Subject: Brunswick Steam Electric Plant, Unit Nos. 1 and 2
Renewed Facility Operating License Nos. DPR-71 and DPR-62
Docket Nos. 50-325 and 50-324
Response to Request for Additional Information - Application to Revise Technical Specifications to Adopt TSTF-439, "Eliminate Second Completion Times Limiting Time From Discovery of Failure To Meet an LCO"

Response to Request for Additional Information

Response to Request for Additional Information

Required Action B.1, One required Nuclear Service Water (NSW) pump inoperable.

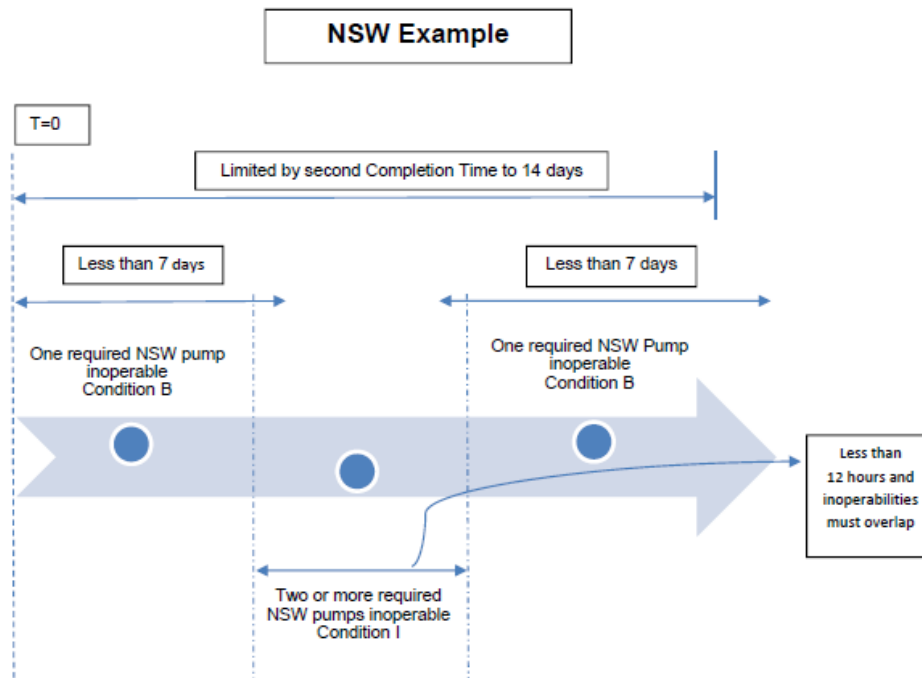
TSTF-439, Revision 2 provides a discussion of each of the specifications affected by the TSTF that justifies deleting the second CTs from the specification in NUREG-1433. The licensee's application does not provide a comparable discussion for the proposed variations. For the specifications listed in the BSEP variations, TS 3.7.2, TS 3.8.1, and TS 3.8.7, provide a discussion similar to that in TSTF-439 for each specification to justify proposed deletions of second CTs. In particular, this plant-specific justification should address the following:

Specification 3.7.2, SW System and Ultimate Heat Sink, has a 7-day Completion Time for one required NSW pump inoperable (Condition B) and a 12-hour Completion Time to be in Mode 3 for two or more required NSW pumps inoperable (Condition I). Condition B has a second Completion Time of 14 days from discovery of failure to meet the Limiting Condition for Operation (LCO).

The SW system is considered operable when it has two operable CSW pumps (unit dependent) and three site of the four NSW pumps (any combination of Unit 1 and Unit 2 NSW pumps). The loss of one NSW pump does not dictate entry into Required Action B.1. The loss of a second NSW pump (one of the three required) would dictate entry into Required Action B.1. This condition would not constitute a loss of safety function. The loss of a third site NSW pump (two of the three required) would dictate entry into Required Action I.1 and constitute a loss of safety function.

For the 14-day second Completion Time to be limiting, entry into and out of Condition B and Condition I must occur multiple times. This scenario would assume the loss of various NSW pumps multiple times, but with none of the overlapping inoperabilities lasting more than 12 hours (Condition I). This highly improbable scenario is further limited by the short Completion Times of Required Action I.1 (Be in Mode 3 within 12 hours) and Required Action I.2 (Be in Mode 4 within 36 hours).

Based on the above, the second Completion Time for Required Action B.1 is not required.

Required Action C.2, One required Conventional Service Water (CSW) pump inoperable.

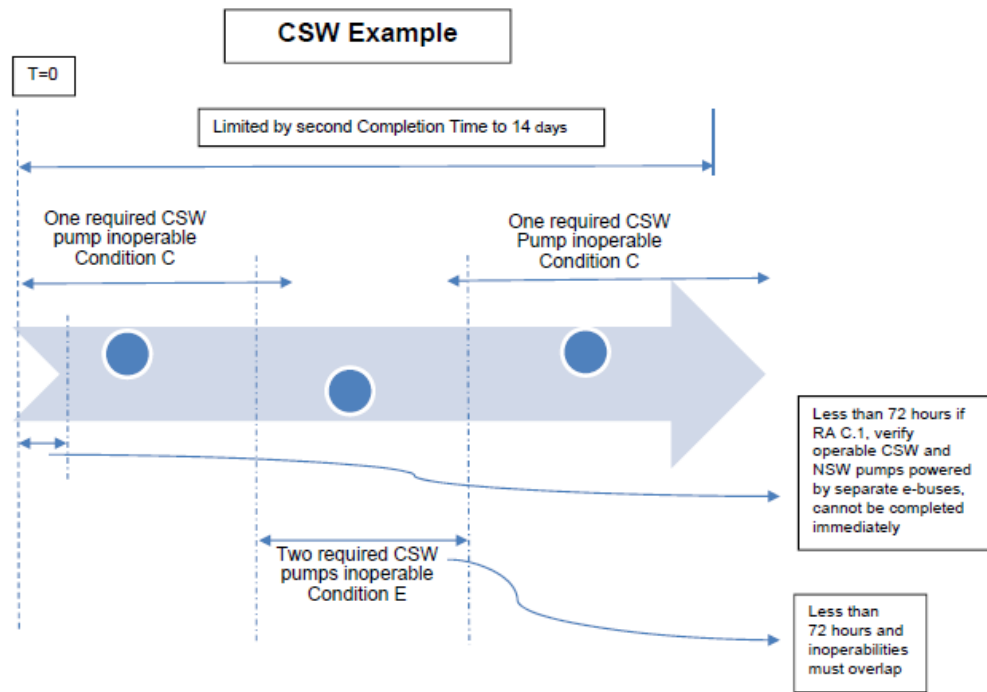
Specification 3.7.2, SW System and UHS, has a 7-day Completion Time for one required CSW pump inoperable (Condition C) and a 72-hour Completion Time for two required CSW pumps inoperable (Condition E). Condition C and E both have second Completion Times of 14 days from discovery of failure to meet the LCO.

The SW system is considered operable when it has two operable CSW pumps (unit dependent) and three site NSW pumps (any combination of Unit 1 and Unit 2 NSW pumps). The loss of one of the three CSW pumps on a unit does not dictate entry into Condition C. The loss of a second CSW pump (one of the two required) would dictate entry into Condition C. With one required CSW pump inoperable, the inoperable pump must be restored to operable status within 7 days. With the unit in this condition, the operable CSW pump and NSW pumps are adequate to perform the heat removal function. The 7-day Completion Time is based on the availability of two unit-specific SW pumps (an operable CSW pump and an operable NSW pump), each powered from separate 4.16 kV emergency buses, to support the unit's service water loads. The 7-day Completion Time is based on the remaining SW heat removal capability, a reasonable time for repairs, and the low probability of an event occurring during this time period requiring the SW System.

With two required CSW pumps inoperable, one required inoperable pump must be restored to operable status within 72 hours. With the unit in this condition, the operable NSW pumps are adequate to perform the heat removal function. The 72-hour Completion Time is based on the availability of the remaining NSW pumps to support the unit's Service Water loads. The 72-hour Completion Time is based on the remaining SW System heat removal capability, a reasonable time for repairs, and the low probability of an event occurring during this time period requiring the SW System.

For the 14-day second Completion Time to be limiting, entry into and out of Condition C and Condition E must occur multiple times. This scenario would assume the loss of various CSW pumps multiple times, but with none of the overlapping inoperabilities lasting more than 72 hours (Condition E). This highly improbable scenario is further limited by the short Completion Times of Required Action I.1 (Be in Mode 3 within 12 hours) and Required Action I.2 (Be in Mode 4 within 36 hours). Furthermore, Required Action C.1, verify the one operable CSW pump and one operable unit specific NSW pump are powered from separate emergency buses, must be completed immediately. If Required Action C.1 cannot be verified, then Condition D is entered which requires the restoration of the inoperable CSW pump to be completed within 72 hours.

Based on the above, the second Completion Times for Required Action C.2 and E.1 are not required.

Required Action B.3, Two Unit 1 offsite circuits inoperable due to one Unit 1 balance of plant circuit path to the downstream 4.16 kV emergency bus inoperable for planned maintenance. AND DG associated with the affected downstream 4.16 kV emergency bus inoperable for planned maintenance. (Unit 2)

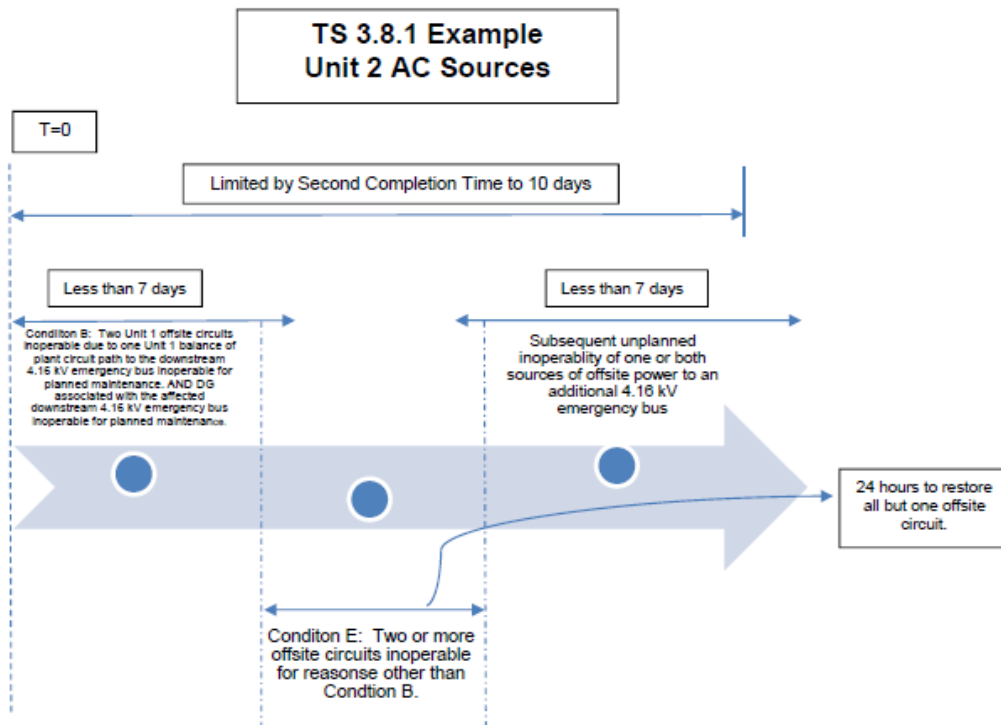
- a. For TS 3.7.2, Required Actions B.1, C.2, and E.1, the identified more restrictive change;
- b. For TS 3.8.1, Required Actions B.3, C.3, and D.5, as applicable, unique TSs due to the BSEP's shared electrical distribution systems configuration and the reference to LCO 3.8.1 NOTES a or b;
- c. For TS 3.8.7, Required Actions A.1, B.1, C.4, and D.1, as applicable, unique TSs due to the BSEP's shared electrical distribution systems configuration.

Due to the shared configuration of the BSEP electrical distribution system, two Unit 1 and two Unit 2 qualified circuits between the offsite transmission network and the onsite Class 1E Distribution System and four separate and independent DGs both Unit 1 and Unit 2 are required to be operable when a unit is in Mode 1, 2, or 3. TS 3.8.1, Condition B was established to allow sufficient time to perform maintenance on the BOP buses and the associated 4.16 kV emergency bus of the opposite, shutdown unit without placing an operating unit in an unduly restrictive Completion Time. To perform maintenance on the 4.16 kV emergency bus, the associated DG must be rendered inoperable.

The second Completion Time for Required Action B.3 establishes a 10-day limit on the maximum time allowed for any combination of required AC power sources to be inoperable during any single contiguous occurrence of failing to meet LCO 3.8.1.a or b. For the 10-day second Completion Time to be limiting, additional unplanned failures would be required. Since Condition B is used to support planned maintenance, normal work control practices would be in place to protect the remaining operable distribution subsystems. As a result, such a scenario is highly unlikely. However, it should be noted that while in this condition each of the remaining three 4.16 kV emergency buses will have their standby emergency source and two sources of offsite power operable. If one or both sources of offsite power are lost to an additional 4.16 kV emergency bus, then Condition E is entered which requires restoration of all but one offsite circuit to operable status within 24 hours.

Condition B is modified by two notes. Note 1 only allows this Condition to be used when the opposite unit is in Mode 4 or 5. For example, when two offsite circuits are inoperable, due to one Unit 1 BOP circuit path and the DG associated with the downstream 4.16 kV emergency bus inoperable, while Unit 1 is in Mode 1, 2, or 3, Condition I (Enter LCO 3.0.3) of Unit 2 Specification 3.8.1 must be entered and the associated Required Actions performed. Note 2 prevents Condition B from being entered coincident with Condition A (the SAT and UAT feeds to the operable BOP circuit path shall both be operable). The Unit 1 BOP buses 1C and 1D are supplied from the Unit 1 SAT and UAT. Inoperability of the Unit 1 SAT or UAT, as provided for in Condition A, would result in the loss of redundancy of offsite power to the operable BOP bus if Condition A and B were allowed to be entered coincidentally. Elimination of the second Completion Time of Required Action B.3 does not impact the applicability of these Notes.

Based on the above, the second Completion Time for Required Action B.3 is not required.

Required Action A.1, One AC electrical power distribution subsystem inoperable for planned maintenance due to either inoperable load group E1 bus(es) or inoperable load group E2 bus(es). (Unit 2)

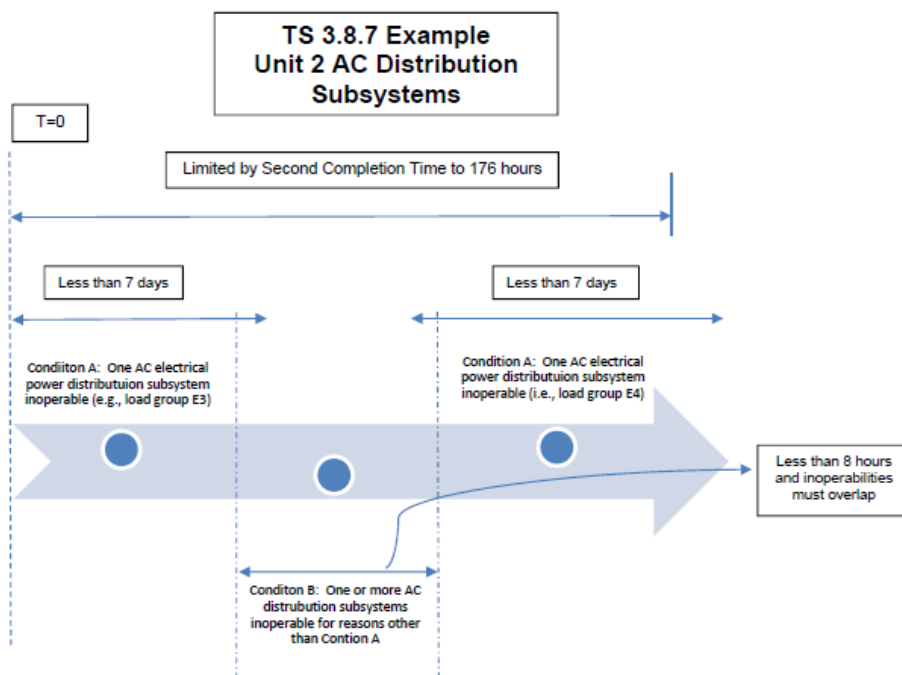
As discussed above, the E1 and E2 load groups are supplied from Unit 1 BOP buses and primarily serve Unit 1 loads. The E3 and E4 load groups are supplied from Unit 2 BOP buses and primarily serve Unit 2 loads. TS 3.8.7, Condition A, was established to allow for maintenance on an electrical power distribution subsystem primarily associated with the opposite, shutdown unit without placing an operating unit in an unduly restrictive Completion

Time. With one Unit 2 AC electrical power distribution subsystem inoperable, the remaining AC electrical power distribution load groups are capable of supporting the minimum safety functions necessary to shut down the operating reactor and maintain both reactors in a safe condition, assuming no single failure in the remaining AC electrical power distribution load groups. If Unit 1 is in Mode 1, 2, or 3, then both the Unit 1 and Unit 2 Required Action B.1 of TS 3.8.7 requires restoration of the associated AC electrical power distribution subsystem within 8 hours of the inoperability. A similar discussion applies with Unit 1 operating and Unit 2 shutdown.

The second Completion Time for Required Action A.1 establishes a 176-hour limit on the maximum time allowed for any combination of required distribution subsystems to be inoperable during any single contiguous occurrence of failing to meet the LCO. For the 176-hour second Completion Time to be limiting, entry into and out of Condition A and Condition B must occur. This scenario would assume the loss of AC electrical power distribution subsystems multiple times, but with none of the overlapping inoperabilities lasting more than 8 hours (Condition B). Since Condition A is used to support planned maintenance on AC electrical distribution subsystems, normal work control practices would be in place to protect the remaining operable distribution subsystems. As a result, such a scenario is highly unlikely and would be further limited by the short Completion Time of Required Action E.1 (Be in Mode 3 within 12 hours). Additionally, any overlapping inoperabilities that result in a loss of safety function requires entry into LCO 3.0.3 per TS 3.8.7, Condition F.

The second Completion Time for Required Action B.1 establishes a 176-hour limit on the maximum time allowed for any combination of required distribution subsystems to be inoperable

during any single contiguous occurrence of failing to meet the LCO. For the 176-hour second Completion Time to be limiting, entry into and out of Condition B must occur. This scenario would assume the loss of AC electrical power distribution subsystems multiple times, but with none of the overlapping inoperabilities lasting more than 8 hours (Condition B). Such a scenario is highly unlikely and would be further limited by the short Completion Time of Required Action E.1 (Be in Mode 3 within 12 hours). Additionally, any overlapping inoperabilities that result in a loss of safety function requires entry into LCO 3.0.3 per TS 3.8.7, Condition F.

Based on the above, the second Completion Time for Required Actions A.1 and B.1 are not required.
